City of West Linn  
**PRE-APPLICATION CONFERENCE MEETING**  
**SUMMARY NOTES**  
June 18, 2009

SUBJECT: Proposed Douglas Park south of Haskins Road

# DOUGLAS PARK

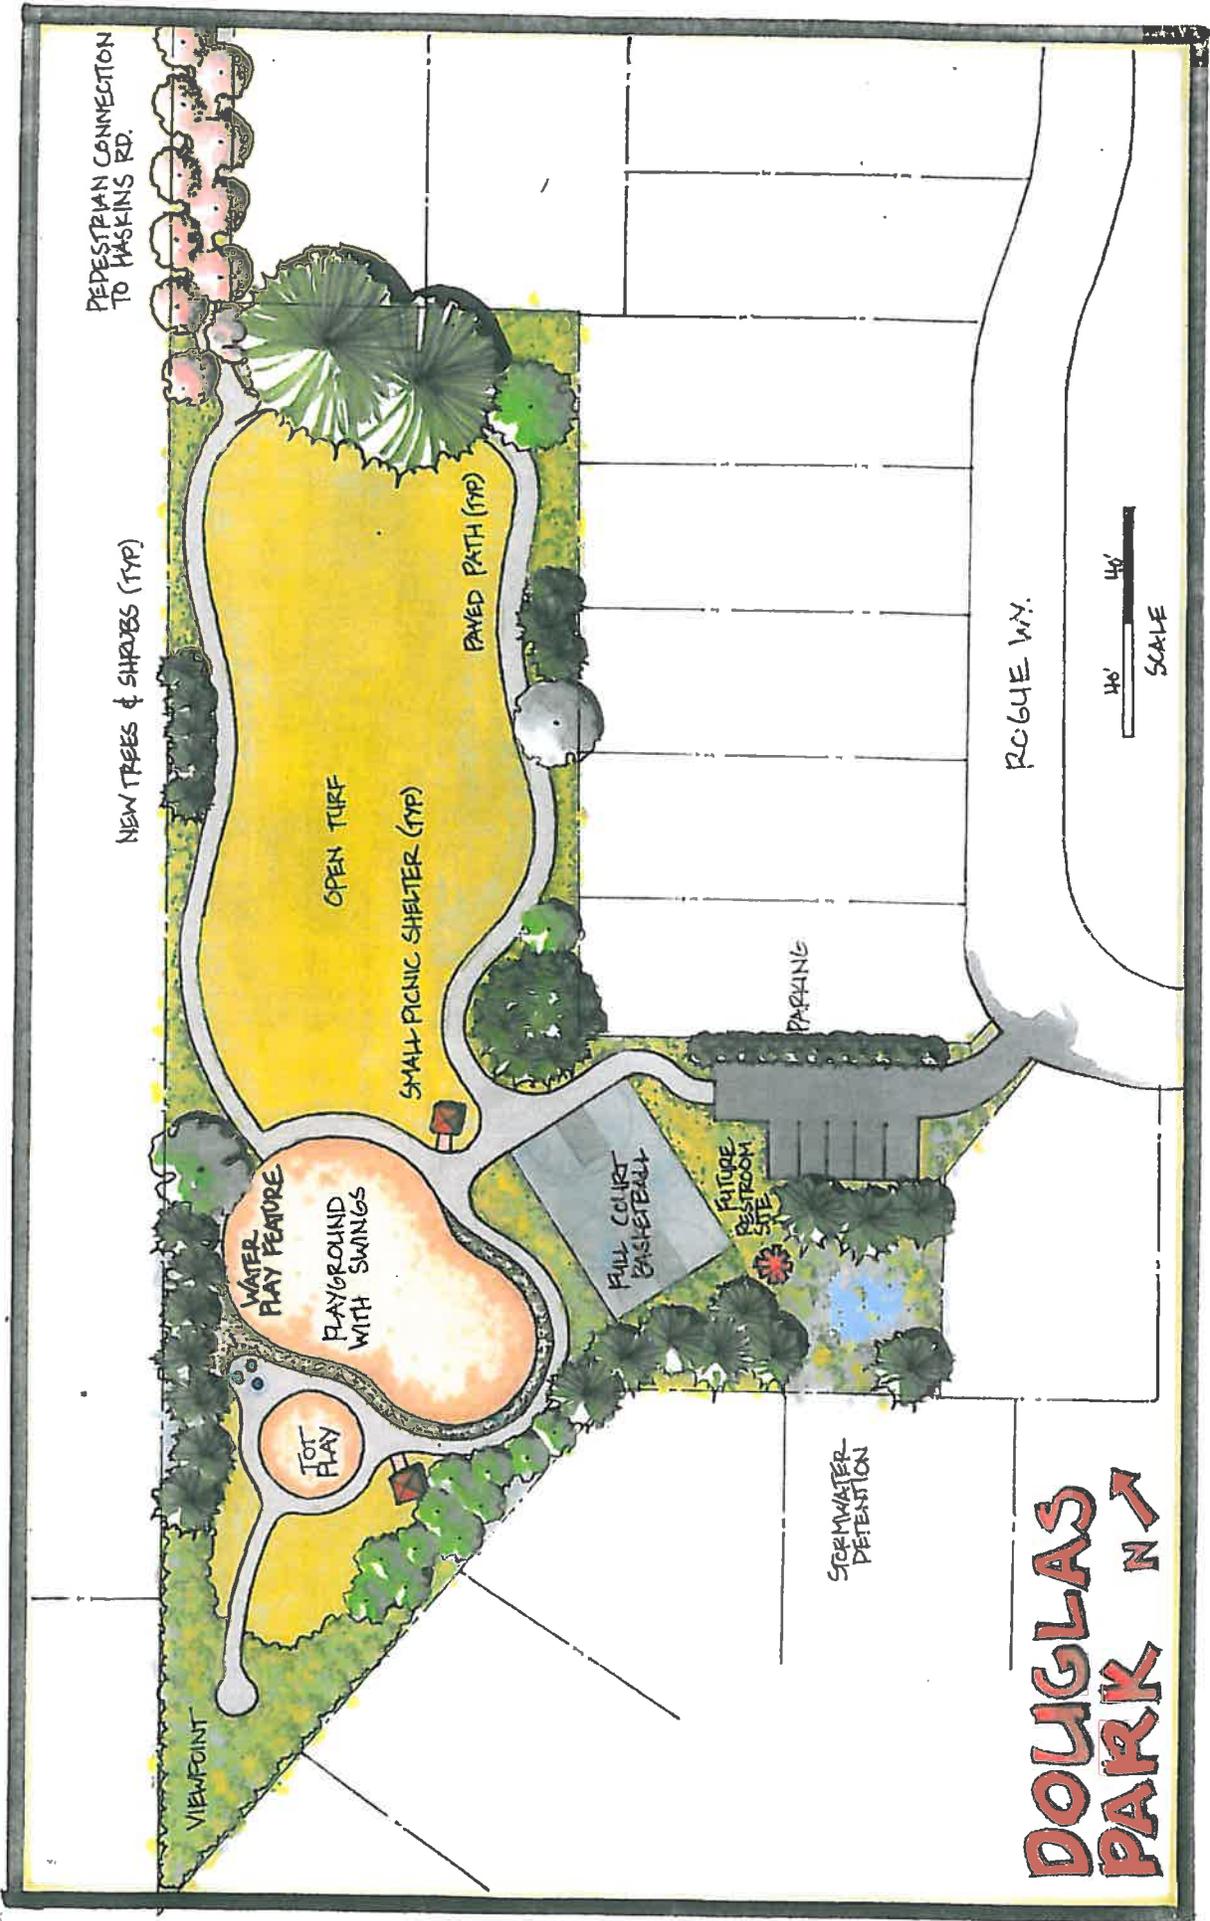
Parking is a concern. CDC chapter 46.090 requires two to five parking spaces per acre. Using the two parking spaces per acre method the proposed parking area for five vehicles is minimally adequate. It also allows for an ADA space as required by CDC 46.150(B). The code allows adjacent ROW to be used for parking. Staff finds that there is no adjacent right of way for parking on Rogue Way since the 20 foot long park frontage is occupied by the access driveway. The ROW adjacent to the park on Haskins Road is only 20 feet in length. Although one car could be accommodated the frontage length fails to meet code requirements.

Staff finds that if there are any informal ball games or practices held at this site, the five parking spaces will be swamped. Increasing the parking lot to five spaces per acre per code to yield 11 spaces (two acres X 5 spaces plus one ADA space) would meet code but it would still be inadequate. An active oriented park should accommodate the reasonably anticipated levels of use and activities.

At absolute minimum, 11 parking spaces should be provided. Even that amount is expected to be inadequate and will likely spawn problems akin to Oppenlander Field and the parking spillover into surrounding residential streets.

Parking should be increased if organized games are expected and if neighborhood complaints are to be avoided. A variance is recommended to increase parking beyond the amount allowed in CDC 46.090(B)(11).

Staff visited the site and noted that this location suffers from isolation and lack of accessibility in the extreme. Frontage on Haskins Road is just 19.75 feet wide. Visitors must then walk 110 feet up this narrow corridor before emerging upon the park. The Haskins Lane access will also be visually limited by the construction of a new house on the east side of the corridor and associated fencing/landscaping. Meanwhile on the west side of that same corridor there is a long line of broad canopied ornamental cherry trees on the Wustrack property which also constrict the view lines.

From Rogue Way there is a similar 20 foot wide frontage leading into the proposed parking lot. The view corridors, narrow as they are will be reduced even further when houses are built on either side of the 20 foot wide Rogue Way access points and associated fences/landscaping is installed on their property lines. Thus the site repeats the ongoing problem of burying parks in obscure strips of land both visually and physically inaccessible to the majority of Tanner Basin residents for whom this is being built.

Staff is concerned that 20 feet of frontage provides no surveillance from the street. Police could drive into the parking lot but that still does not offer any line of sight to most of the turf area, playgrounds or tot play area. Surveillance from neighboring homes is better in many cases would be obstructed by trees and fences. A Class II Variance would be required to waive the CDC 56.100(G)(6)(7) surveillance standard.

The proposed driveway will have a narrow 20 foot wide corridor on Rogue Way to negotiate. CDC Chapter 48.040(A)(1) requires non-residential driveways serving two way traffic to be at least 24 feet wide curb to curb. That is not even including the driveway wings which are usually three feet on each side. Thus a Class II Variance is required for the access driveway.

Collect and provide treatment for additional storm drainage run-off generated from new impervious area of more than 500 square feet.

Collect and provide detention for additional storm drainage run-off generated from new impervious area of more than 5,000 square feet.

Mr. Worcester stated that the number of parking spaces would probably not vary from the amount originally proposed and that grasscrete or similar material would be used to reduce impermeable surfaces.

Mr. Worcester noted the current budgetary limitations make anything other than the “as is” option impossible.

Mr. Worcester noted that in addition to water permeable driveways/parking the basketball court would be reduced in size to reduce treatment/detention requirements.
